Responses to Examiner's Remarks in Detailed Action

Appl. No. 10/774,544
Response to Office Action of 2/24/05
Response Dated May 24, 2005

FIG. 2

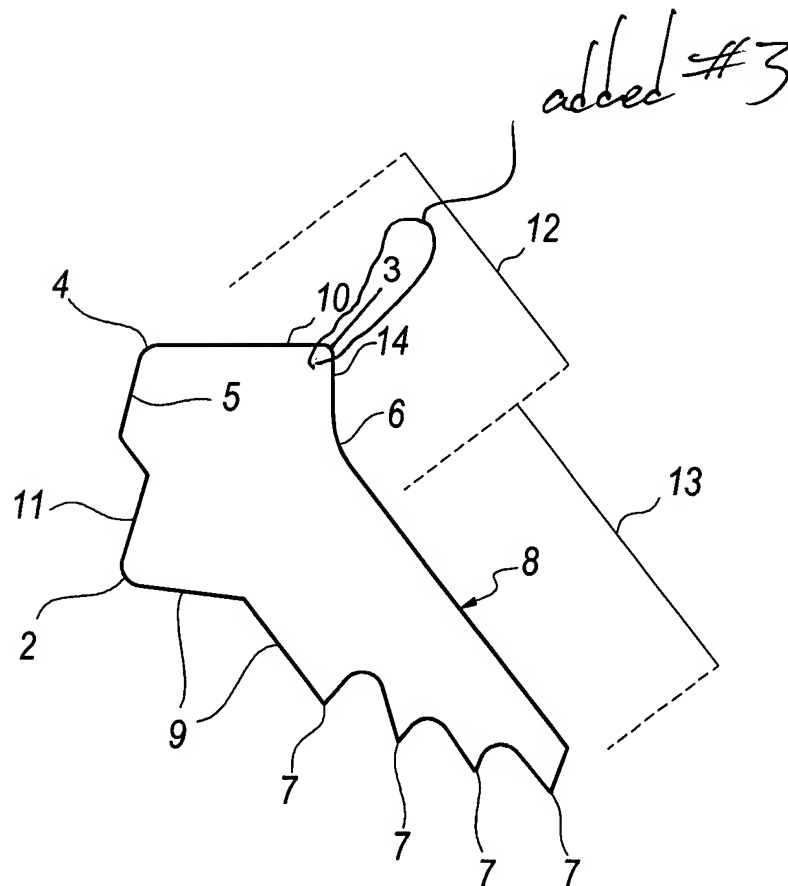
In response to Paragraph 2, the Applicant has (1) amended Figure 1 to include a reference numeral 49, designating the area of the cavity, and (2) amended Figure 2 to show the location of the forward brake 3. Such amendments are shown in the attached Replacement Sheets (Appendix A) and Annotated Sheets (Appendix B), and are believed to satisfy the requirements of the Examiner in Paragraph 2. If additional issues are discovered, Applicant invites a telephone call for the possibility of an examiner's amendment.

Figure 2: Reference numeral 3 has been added to designate the forward brake.
